Certification Labels - Incorrect GAWR Information

Bulletin Type:	Recall	Publication Date:	September 2025
Bulletin #(s):	25V-578 US 2025-452 Canada	Make(s):	Jayco
Job Code(s):	9901638	Model(s):	Seismic FW
Flat Rate(s):	9901638 - 0.3 Hr. Labor - Replace Certification Label	Model Year(s):	2026

Certification Label

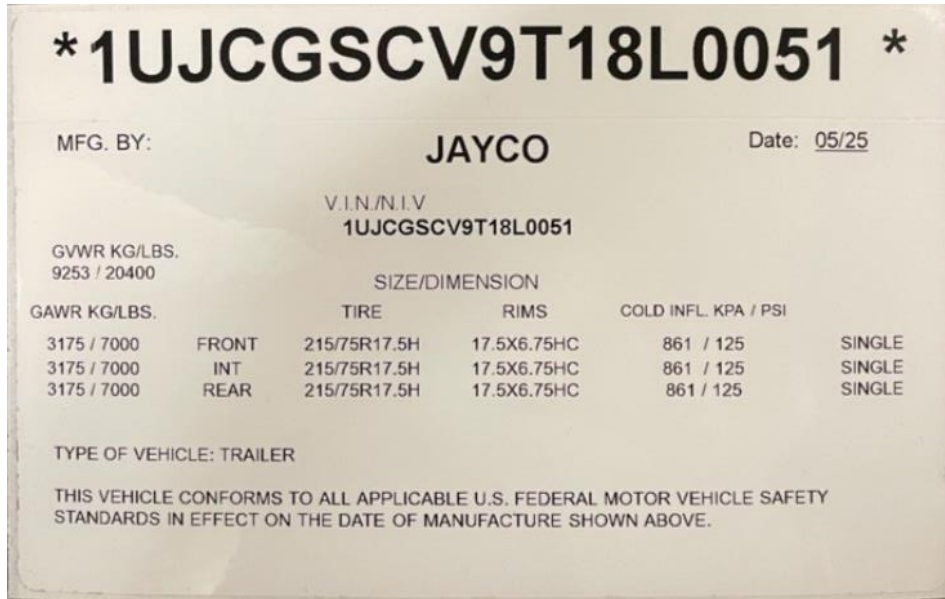
Incident:	Certification labels have the incorrect GAWR listed. Labels show 8000 LBS. GAWR and need to show 7000 LBS GAWR.
Affected Units:	2026 Jayco Seismic FW
Part:	Part: Certification Label enclosed in owner/dealer notification letter
Misc. Tools & Supplies:	Isopropyl alcohol Shop rag
Parts Return Information:	N/A

The certification label below is only an example of the label you are to replace.

1. Travel trailer models locate the certification label on the off door side front of unit.
2. Remove the existing label. Using isopropyl alcohol and a shop rag, remove any adhesive residue from the surface where the original label was removed.
 - a. Allow the area to dry for at least 30 seconds.

1. Remove the protective back from the new label. Align the new label in the same location of the original label and apply it to the surface. Remove any air bubbles from the label.
 - a. **Note:** Do not attempt to remove or adjust the label once it has touched the surface. Doing so may damage the label or cause it not to adhere properly to the surface.
